Project No. 07516-42-02  
May 10, 2023

Subject: RESPONSE TO CITY OF SAN DIEGO REVIEW COMMENTS  
NAKANO  
SAN DIEGO, CALIFORNIA

- References:
1. Project Issues Report, Nakano Discretionary Project, PRJ-1076302, City of San Diego, Geology Review Comments prepared by Kreg Mills, dated April 21, 2023.
  2. *Update Geotechnical Investigation, Nakano Property, Chula Vista, California* prepared by Geocon Incorporated dated September 18, 2020 (Project No. 07516-42-02).
  3. *Addendum Geotechnical Report and Response to City of San Diego Review Comments, Nakano, San Diego, California*, prepared by Geocon Incorporated, dated February 9, 2022 (07516-42-02).
  4. *Nakano, Grading and Storm Drain*, prepared by Civil Sense, Inc., dated May 12, 2022.

**GEOLOGIC MAP**  
 NAKANO  
 CHULA VISTA, CALIFORNIA

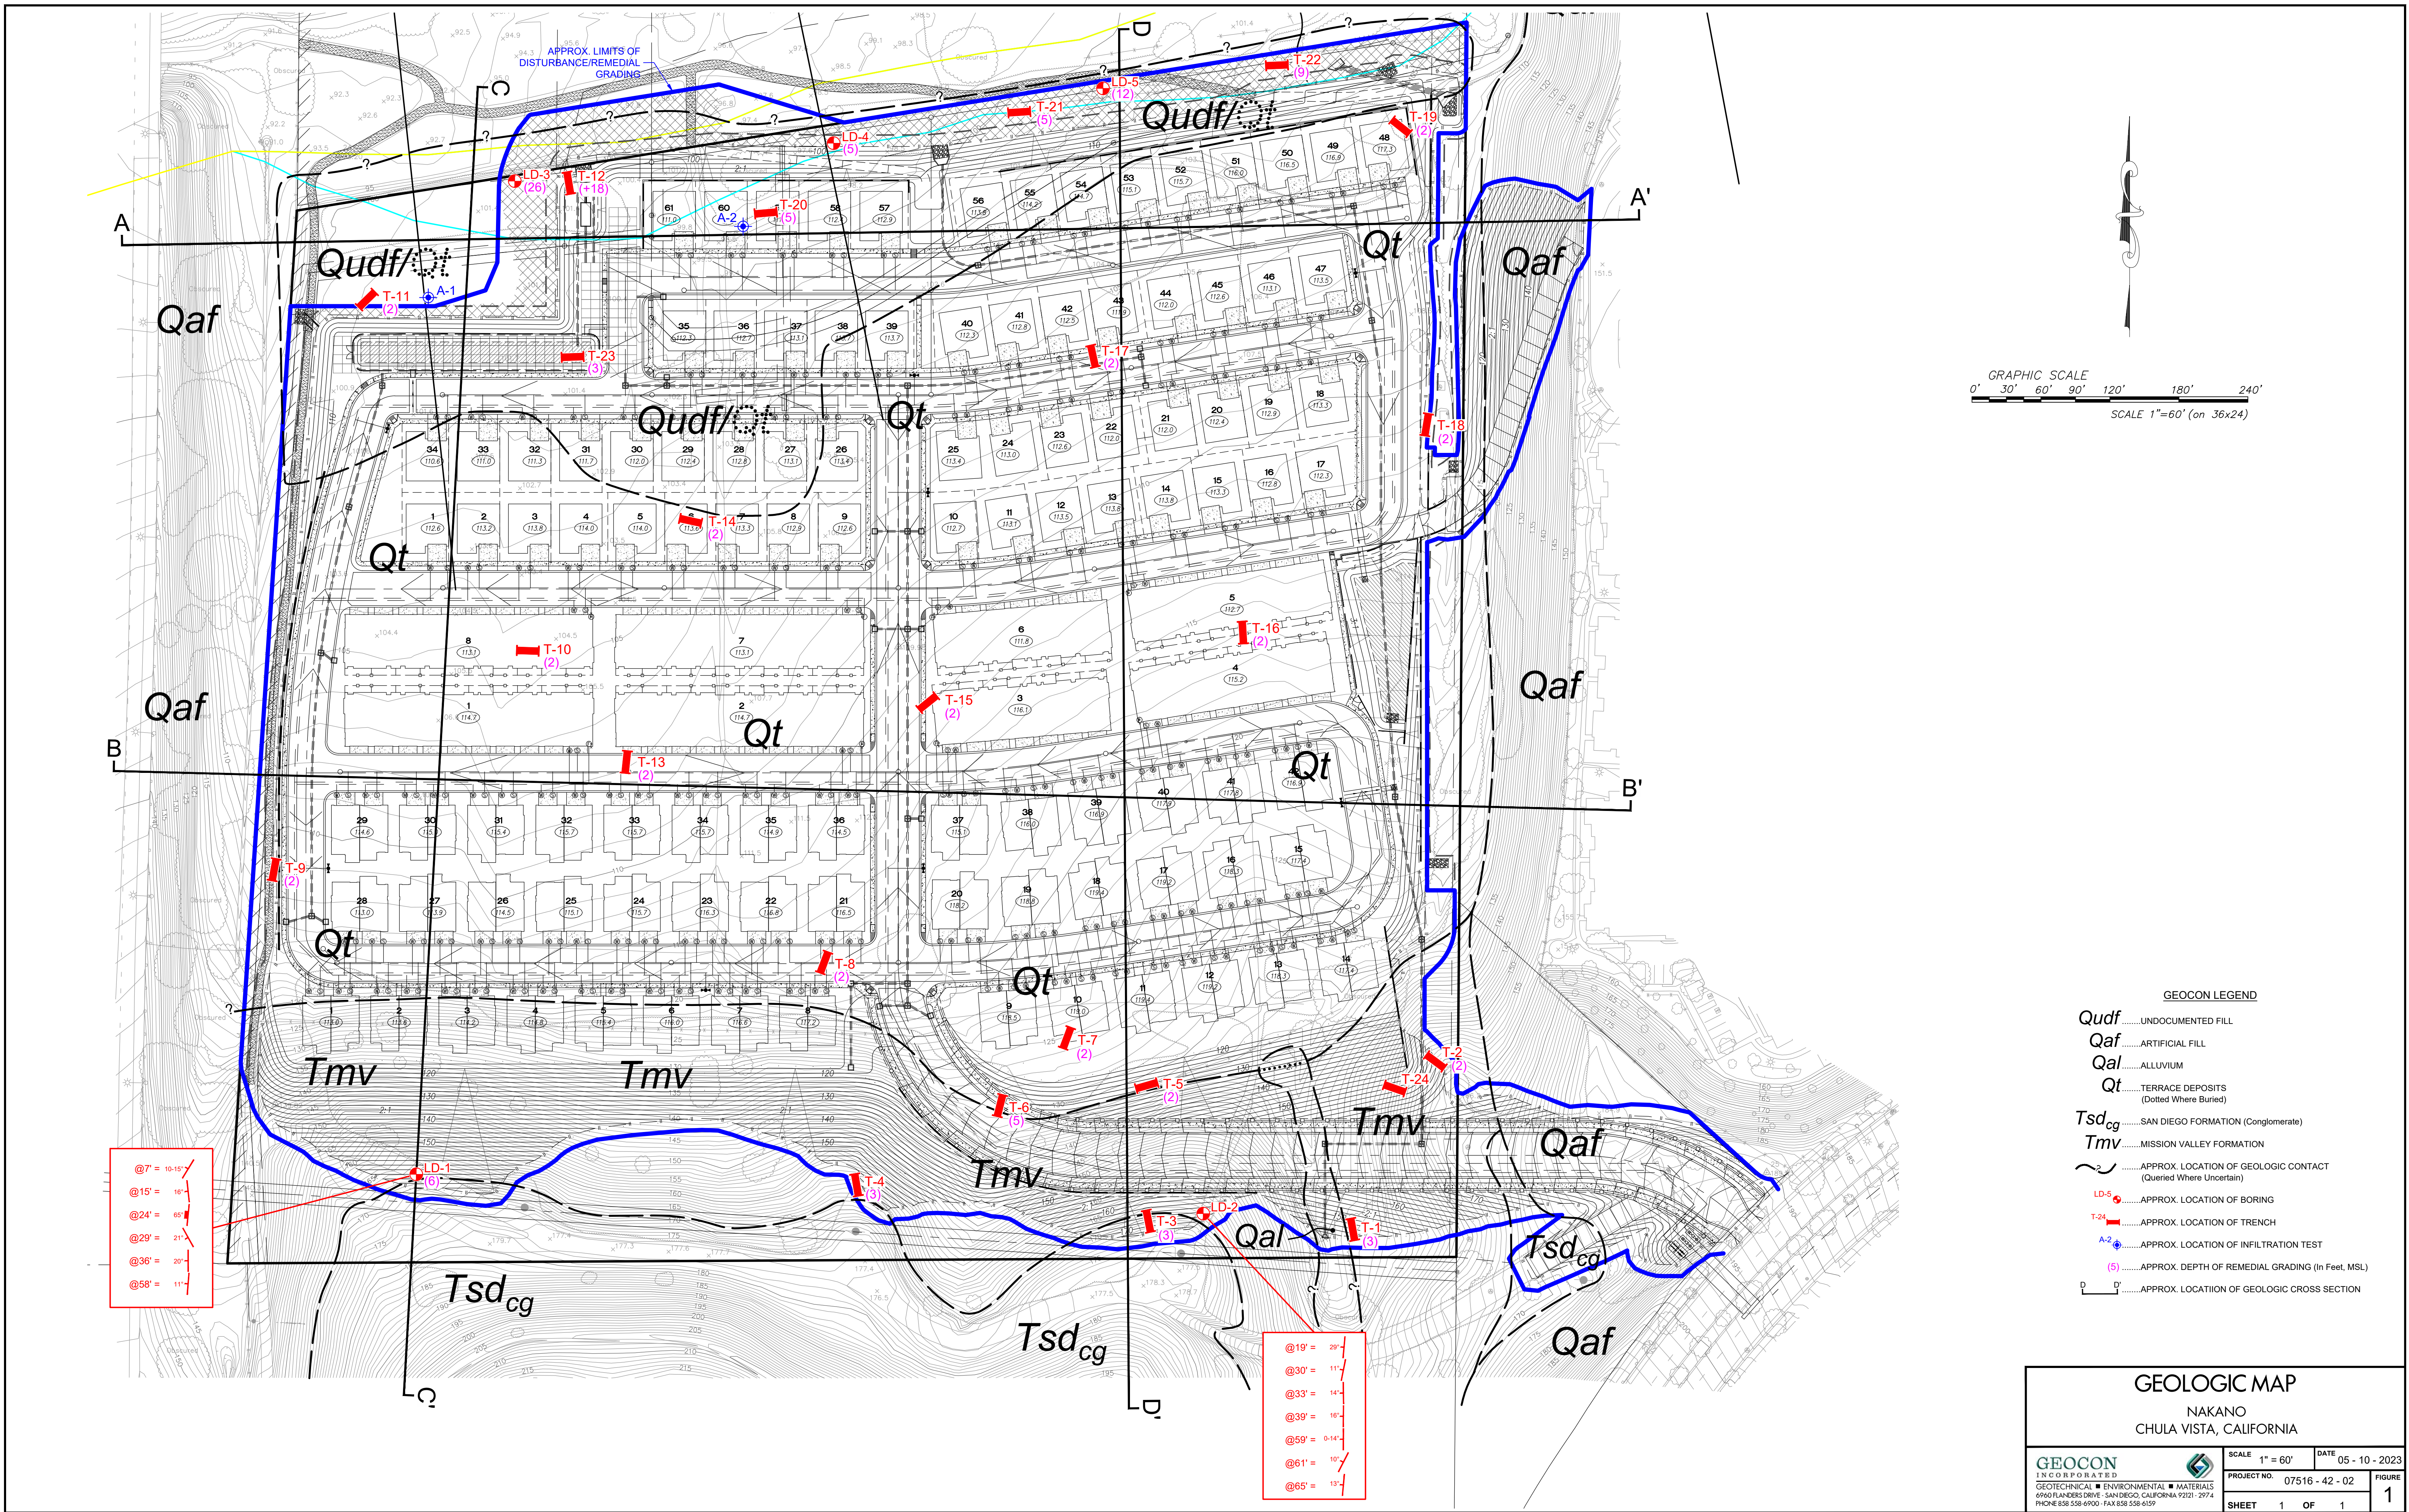
**Issue 51:** *The limits of the proposed development appear to have changed since the submitted report was prepared. Provide an updated Geologic Map (Figure 2) that shows the current proposed development. Circumscribe the limits of anticipated remedial grading on the updated map to delineate the proposed footprint of the project.*

**Response:** Figure 1 is the requested updated geologic map using a CAD file of Reference 4 as the base map. Figure 1 shows the proposed development and the disturbance limits and limits of anticipated remedial grading. Cross sections are provided on Figures 2 and 3.

**Response:** To evaluate the potential for liquefaction and groundwater impacting removals, we performed three large-diameter borings on the norther edge of the development at the locations shown on Figure 1 (Borings LD-3 through LD-5). We encountered undocumented fill overlying alluvium and terrace deposits. Seepage was encountered near a depth of 33 feet in boring LD-3. The seepage is below the expected removal bottom and within the underlying terrace deposits. Logs of the borings are appended.
